Figure 1

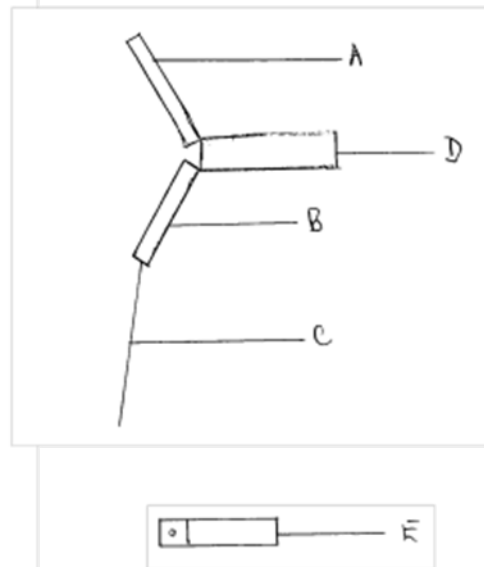
5 The device depicted in figure 2 consists of a calibrated pressure sensor gauge (A), an electrode (B) attached to a guide wire (C), wherein A and B are both attached to one end of an anchor (D) effectively forming a “Y” shape. Also provided is a remote control (E) that operates using radiowaves. Figure 1 depicts the device when in use inside the bladder (1), with the guide wire attaching to the fast twitch muscle sphincter (3) as opposed to the slow twitch muscle sphincter (4).

- 22 At the the hearing I pointed out that the formal drawings provided by (and drawn by) Dr Nduka on 9 January 2009 do not show such a shape difference. In these drawings the device is shown in a “Y” configuration only. Dr Nduka commented that if one measured the angles of the devices depicted in the formal drawings it would be clear that the angles did differ. He referred to the decision of Lord Diplock in *Catnic*<sup>3</sup>, and although Dr Nduka’s recollection of the facts at the hearing was not identical to those of the *Catnic* case, I think that the point that Dr Nduka was trying to make was that the angles claimed were of significance and that the drawings can be used to interpret the claims. In light of this, according to Dr Nduka, a skilled person reading claim 3, in the context of the drawings and the slight variation in angles of the arms of the device, would understand that the claim related to the moveable feature of the arms.

- 23 I have studied the drawings in view of what was disclosed in the description as filed. Whilst the hand-drawn figures do show an apparent shape change, this is not replicated in the formal drawings, i.e. those drawings that form part of the published application. This suggests to me that the shape change was not considered to be of technical significance at the date that the application was filed.

- 24 In addition, the device as drawn appears to consist of three solid portions, which are apparently manufactured from titanium. A solid arm of this sort would only be flexible if it were situated on a hinge or a pivot, yet no such hinge or pivot is disclosed in the specification. Moreover there is nothing in the description that suggests any form of flexibility in the device. In fact, the text accompanying the drawings as filed also states that the “above design allows stability after it is implanted in the bladder”. Stability would suggest that it remains in position, or retains its shape. Therefore I cannot see how a skilled person would understand claim 3 to mean that the arms of the device were adjustable in the manner that Dr

- 29 The description filed on the 14 April 2010 was a single hand-written page, accompanied by a single page comprising two drawings. The embodiment described is a bladder sphincter stimulating device of a very specific structure, a Y shaped device as depicted in Figures 1 and 2 reproduced above, which is made from titanium (ie inert) components.
- 30 Dr Nduka pointed out on several occasions during the hearing that a skilled person would read the claims in light of the description and would realise that they were limited to the embodiment he disclosed. As I emphasised at the hearing, whilst the skilled person would read the description in order to understand what the claims mean, it is the claims themselves that define the part of the invention that one wishes to protect and so their scope must be commensurate with the contribution that the applicant has made to the art.

- 44 However, in view of my analysis above, I do consider that that the specification as filed discloses a specific embodiment in the form of the Y shaped device depicted in the figures, and would support a claim(s) limited to such a device. If the claims were limited to such an embodiment, it does not appear that the prior art documents presently cited would anticipate or render obvious such a narrowed claim.
